MODIFICATION SHEET NO. RDSO/2014/EL/MS/ 435, Rev. '0' Dated 06.06.2014

- 1.0 **Title:**
Modification sheet to avoid necessity of cab changing in case of failure of processor cards of VCU of three phase locomotive (WAP7).
- 2.0 **Object:**
Presently, in three phase locomotives provided with Vehicle Control Units based on MICAS-S2 communication protocol between different bus stations, it is not possible to have redundancy among VCU-1 and VCU-2 in case STB/HBB processors failure and cab changing is needed in some cases by driver to clear the section. However in TCN based VCU, this feature has successfully been implemented by M/s BHEL. Based on the experience gained, new wiring required for modification in locomotives provided with MICAS based VCUs was finalized by RDSO in association with CLW and MS-429 was issued to avoid necessity of cab changing in WAG9/WAG9H locomotives. Further similar modification has been implemented in one WAP7 locomotive (30381) by CLW. Based on above, this MS for WAP7 locomotives has been prepared to implement in all MICAS- S2 VCU based WAP7 locomotives.

OUTPUT REDUNDANCY FOR AVOIDING CAB CHANGING

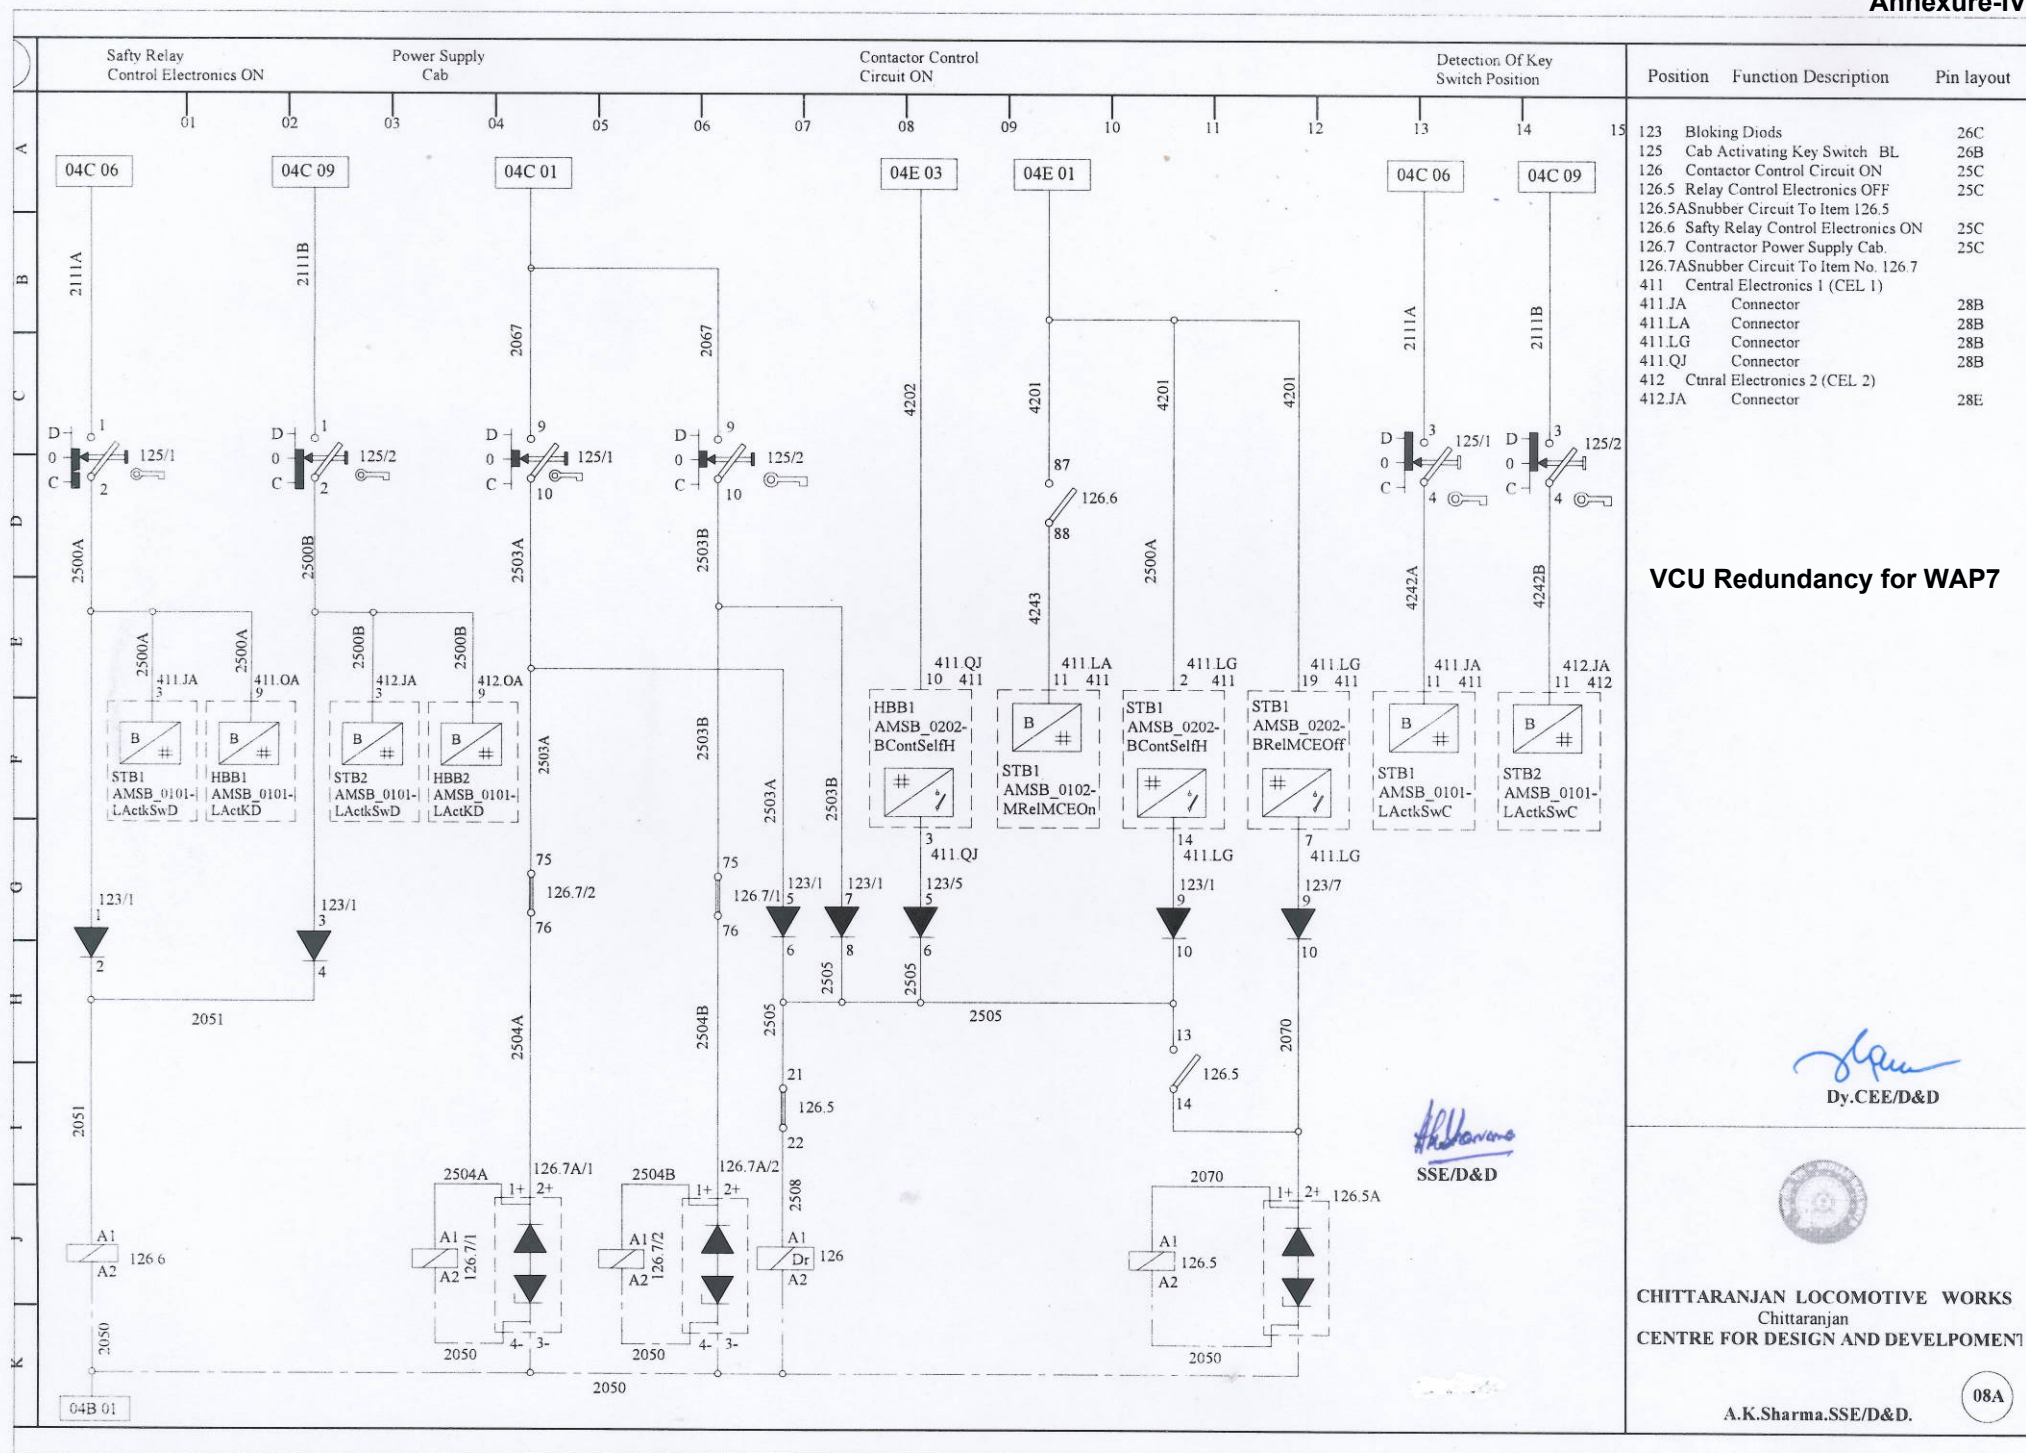
- 4.0 **Modified Arrangement to replace existing arrangement as given above in 3.0:**
The modified arrangement of wiring for the input/output signals with related processors for WAP7 is given in Annexure-I with red colour along with wiring details.

VCU Redundancy for WAP7

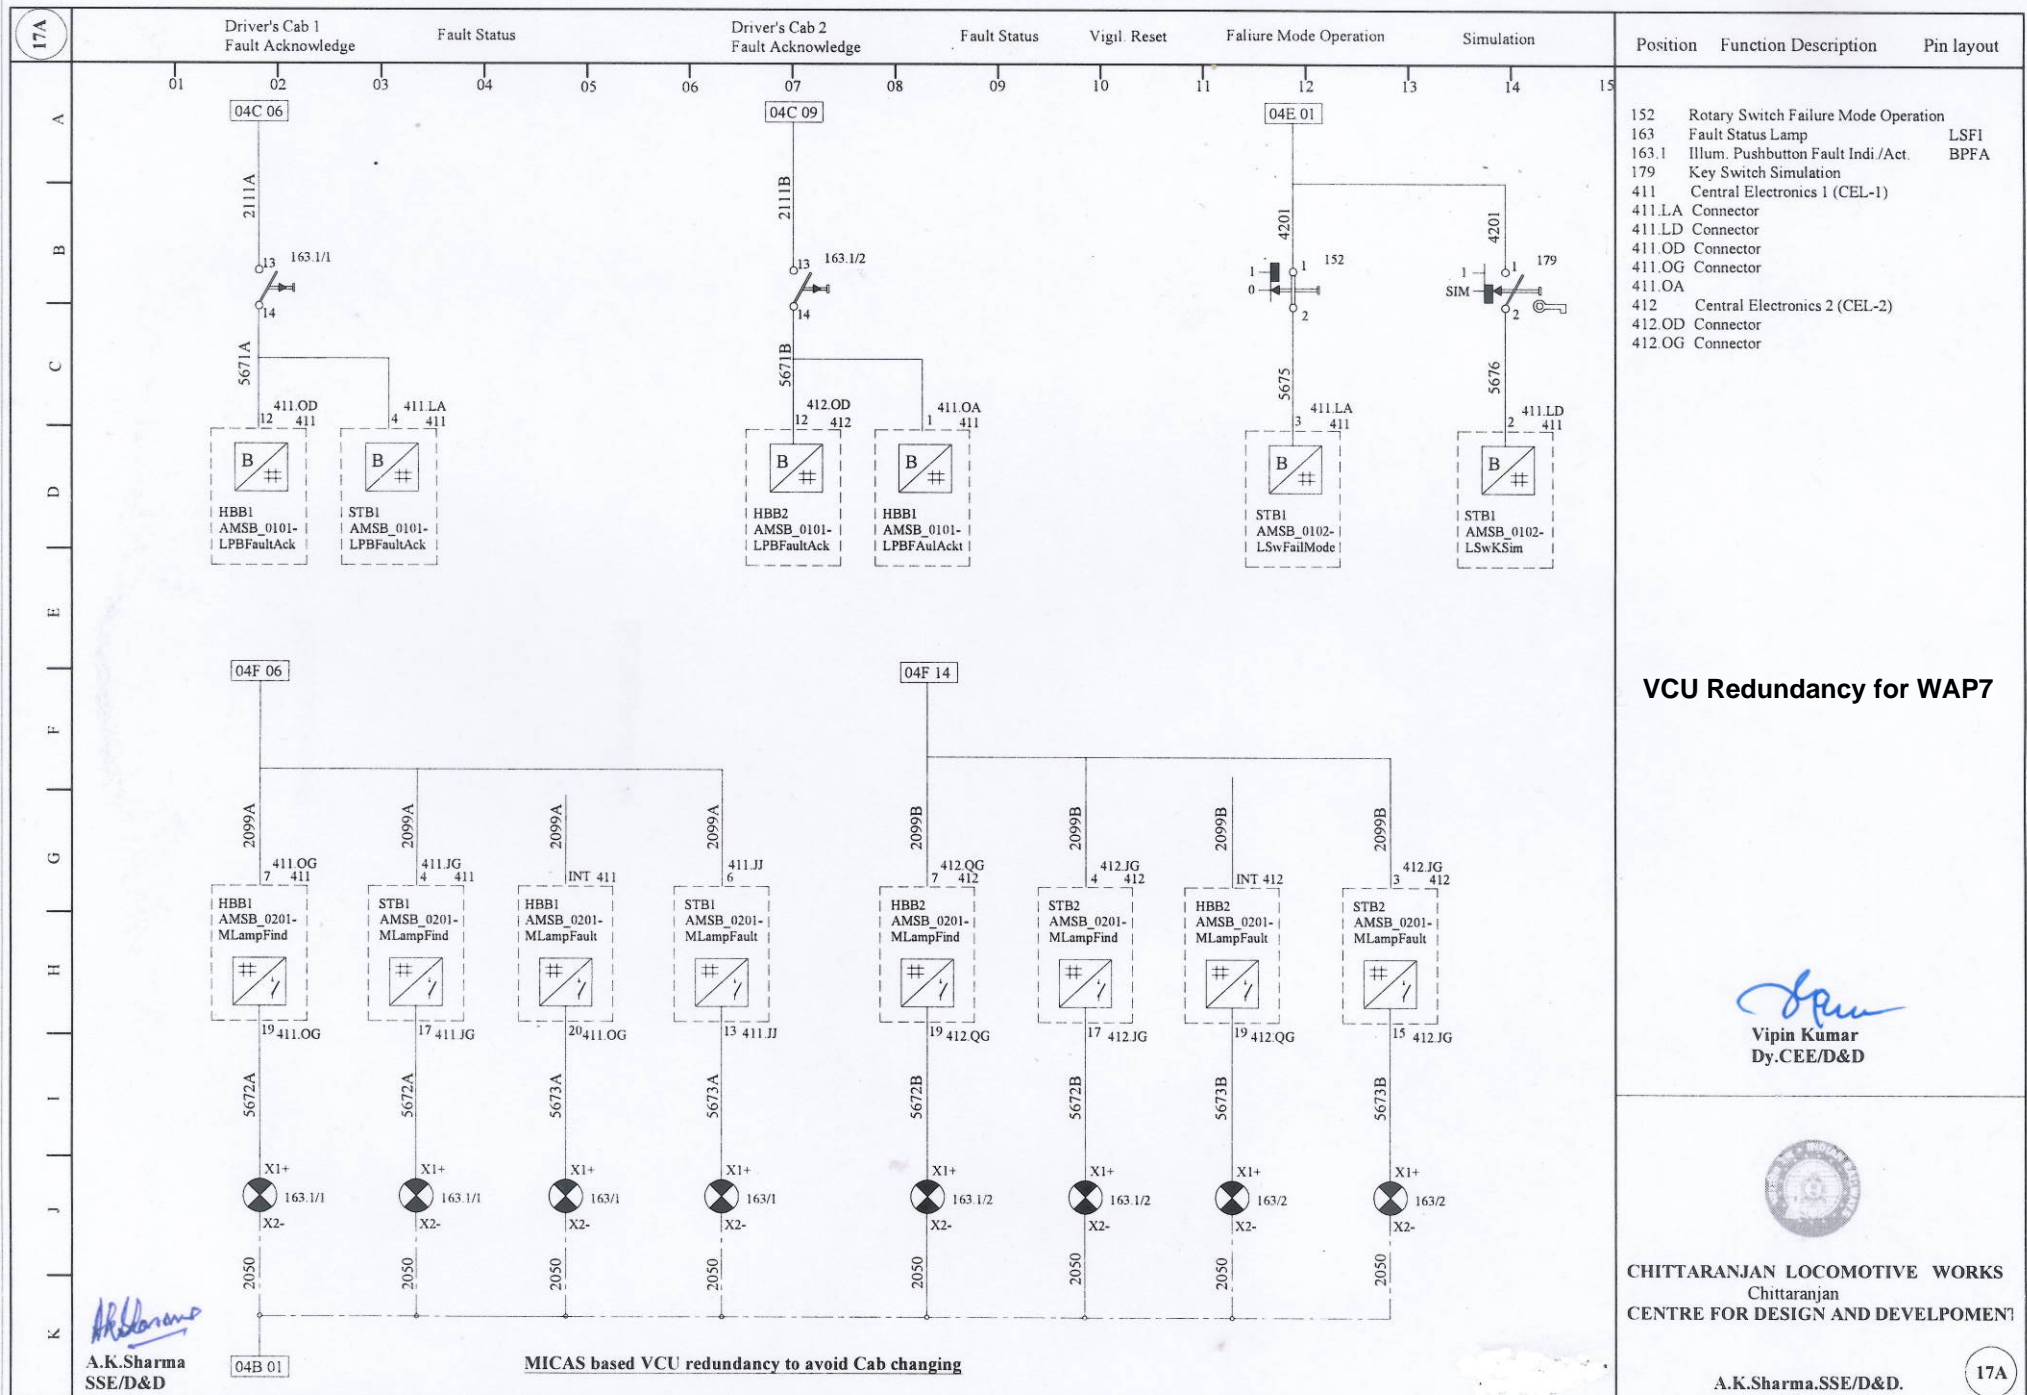
- 3.0 **Existing Arrangement with cross-references of respective design document:**
The existing arrangement of wiring for the input/output signals with related processors is given in Annexure-I for WAP7 locomotive with green colour.
